SUMMARY AND RESPONSE TO PUBLIC COMMENTS

Permit No: Aquifer Protection Permit (APP) No. 511633, LTF 61397

Facility Name: Gunnison Copper Project

Prepared By: Arizona Department of Environmental Quality (ADEQ)
Groundwater Section
1110 W. Washington Street
Phoenix, Arizona 85007

Figure 17: Portion of Figure 44, Appendix I, showing the five-spot pattern for injection/recovery wells.

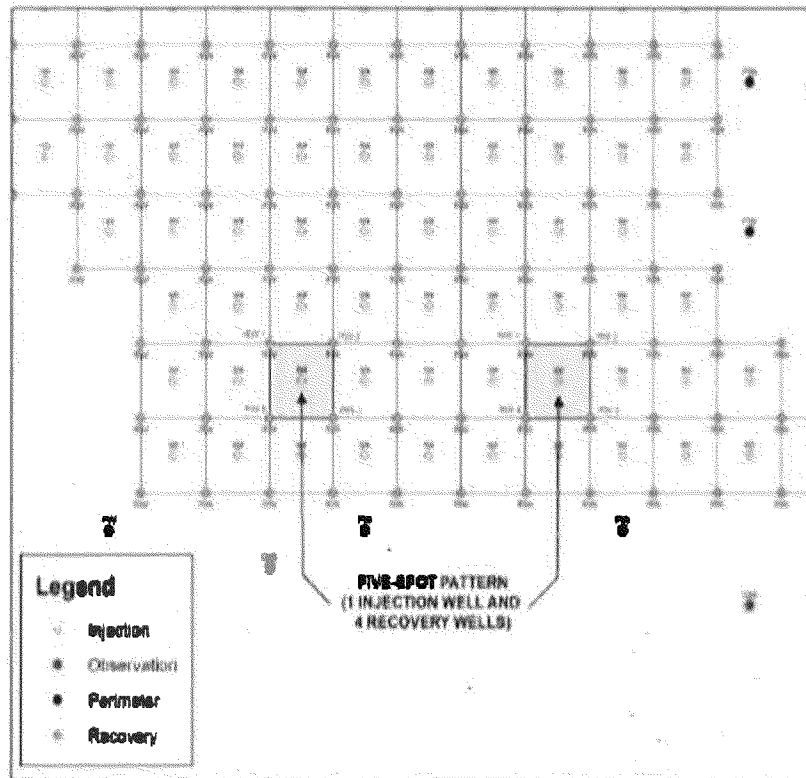
The well layout would have four collection wells surrounding each injection wells. However, the map of the well field (App I, Figure 44, shown below in the review of

groundwater modeling as Figure 17) shows a 5-spot well pattern that shows that each collection well would be part of the four collection wells for at least four injection wells. The development blocks (App I, Figure 45) indicate that sections of the well field would be developed such that 5-spot patterns would overlap with adjacent 5-spot patterns which would cause the 4:1 collection to injection well ratio to not hold throughout the project life.

As discussed throughout the application and response to ADEQ comments, the 5-spot pattern is the base design for in-situ mining. In Stage 1, 200 injection/recovery wells are planned to be constructed. Each 5-spot is planned to be part of other 5-spots. For example, each of the recovery wells for one 5-spot will be recovery wells for the adjacent 5-spots. Therefore, the recovery well to injection well ratio will vary, as planned, over the life of the mining operation. The ratio of the amount of fluid injected to the amount of fluid recovered in each mining block will remain approximately 1:1.

Figure 20: Figure 60 from Appendix I showing the simulated groundwater contours and groundwater velocity vectors for model layer 3, year 21, the end of Stage 3 mining.

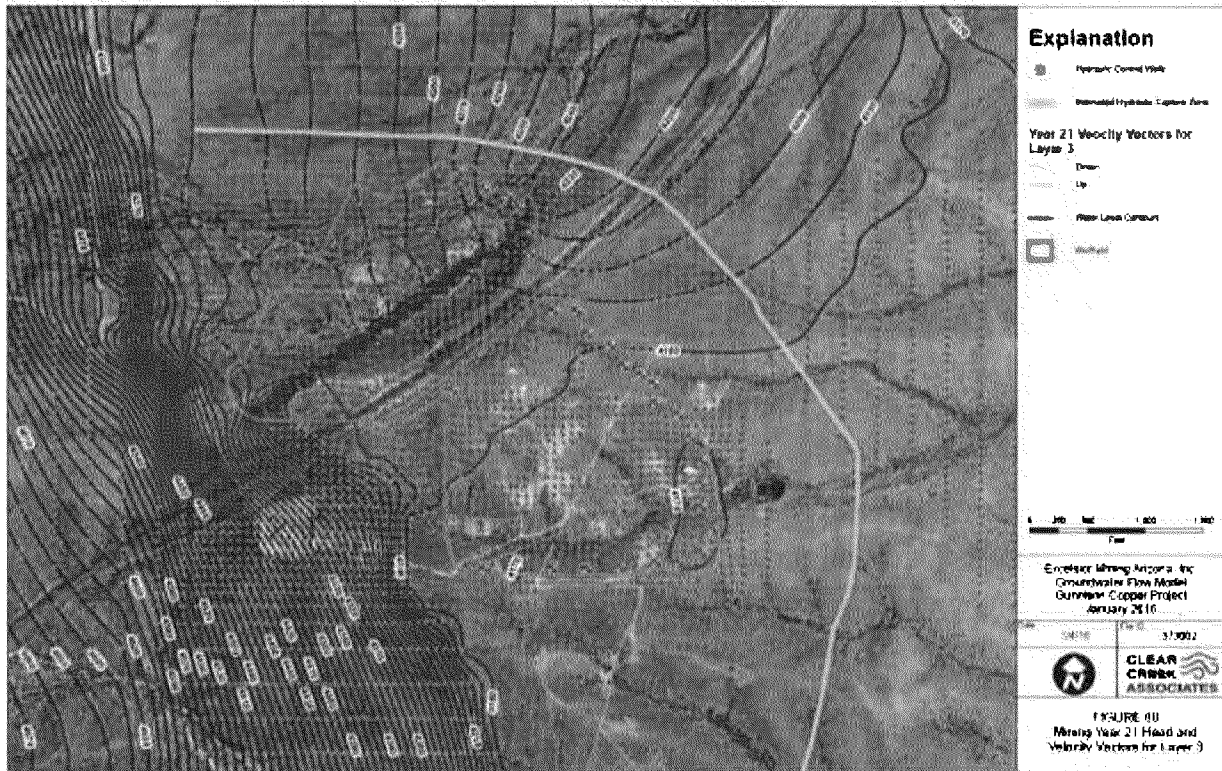
Not all areas within a drawdown cone are areas in which the groundwater flow is toward the middle of the cone. If the baseline groundwater contours dip steeply in one direction, a drawdown may just be a change in slope and the flow may still be away from the cone. Figure 20 shows groundwater velocity vectors (arrows showing direction with the length of the arrow proportional to the speed of groundwater flow) and the groundwater contours (not drawdown) for year 21 (not accounting for injection/collection wells). On the north, west, and south, the groundwater contours naturally slope steeply toward the well field, but in the east and southeast the contours define a relatively flat surface. The surface is so flat that small changes would could cause directional changes in the velocity vectors. The contours in Figure 20 are based on the average head for a specific cell. There is a 4170 contour around the southeast corner of the wellfield delineates a trough in the contours, meaning that simulated flow is to

the center of the trough. Based on the estimated capture zone line, the yellow line on Figure 20 which shows the position of the groundwater divide, the water level is relatively flat throughout the southeast quarter of the wellfield. The mound in the water table represented by the capture zone line is only a few feet higher than the water table in the southeast corner of the project. The pressure at different levels in the groundwater, from the water table surface to a point below the well field, could easily vary from that estimated by consideration only of the water table due to different transmissivity flow paths. Contaminants could escape from the hydraulic control through preferential flow paths through the mapped divide because the average heads in the model cells may not represent actual heads in the fracture zones.

Clear Creek should provide figures similar to Figure 20 for other time periods and for other model layers. Simply maintaining a drawdown is insufficient; it is necessary to maintain a hydraulic low point wherein no flow from the well field can escape into the regional flow field.

ADEQ does not agree that the POC wells should be redesigned based upon contaminant transport modeling or that contaminant transport modeling is required. The constituents that are being monitored are conservative, in that they travel at the same velocity as groundwater, therefore use of particle transport is appropriate.

ADEQ does agree that additional water level maps in other model layers may be informative and as stated above in ADEQ response to Comment #5.1, ADEQ is requiring Excelsior to reevaluate and update the groundwater flow model. If during the evaluation, it is determined that evaluating other model layers beside Layer 3 for head and velocity vectors, these figures will be included in the groundwater flow model evaluation and update report.
